AMENDMENTS TO THE DRAWINGS

REMARKS

These remarks and the accompanying amendments are responsive to the Office Action dated February 19, 2008 (hereinafter referred to as the "Office Action"). At the time of the last examination, Claims 1 and 3-9 were pending, of which Claim(s) 1 and 6 are independent. The Office Action rejected Claims 1 and 3-9. By this response, the independent Claims 1 and 6 are amended, dependent Claims 5 and 7 are also amended, and dependent Claims 4, 8 and 9 are cancelled. Accordingly, upon entry of this amendment, Claims 1, 3, 5, 6 and 7 will be pending, once again with only Claims 1 and 6 being independent.

Fig. 1.
(Prior Art)

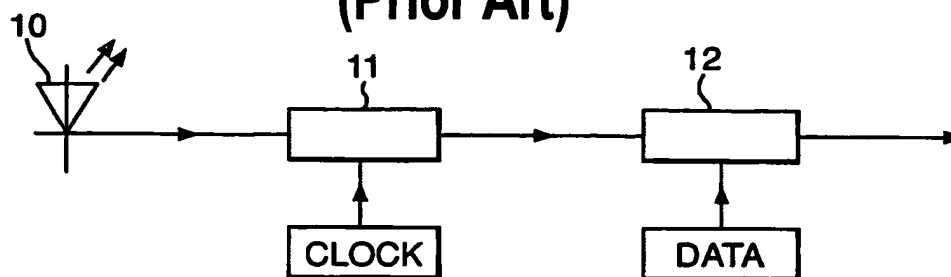
Attached is one (1) sheet of replacement drawings containing Figures 1-2. Figure 1 has been amended to be designated as "Prior Art". Please replace the original drawings containing Figures 1-2 with the attached replacement drawings containing corresponding Figures 1-2.

Sections 3 and 4 of the Office Action objected to the drawings. In response, this amendment includes corrected drawings that amend Figure 1 to include the "Prior Art" identifier. Thus, this response is indeed responsive to the objection to the drawings.
